TECHNICAL BULLETIN

[Issue No.] T40-0006

[Title] MELSEC-Q series CPU module battery backup time reduction and the corrective actions

[Relevant Models] Q2MEM-2MBS

SRAM card back label

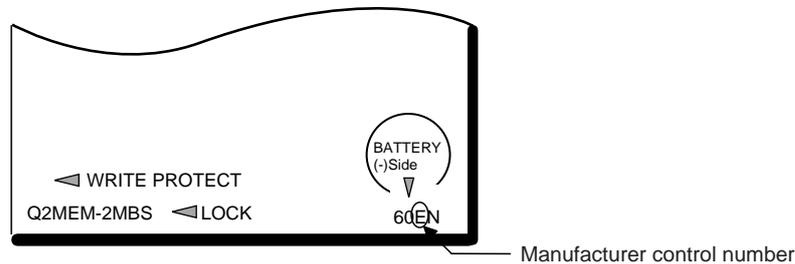
Manufacturer control number can be checked with the number (the 3rd digit from the left) marked on the lower right of the SRAM card back label. Manufacturer control number "E" or later is the target memory card.

SRAM card back label

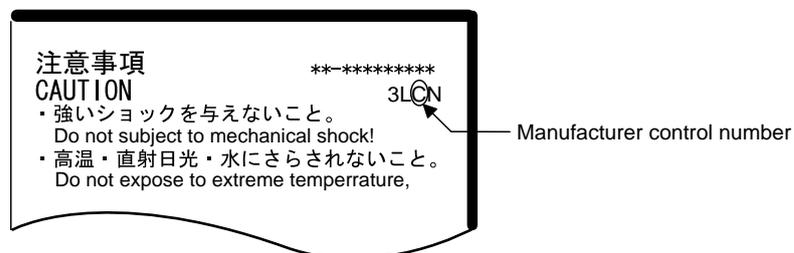
For manufacturer control number "C" or earlier, the number is marked on the upper right.
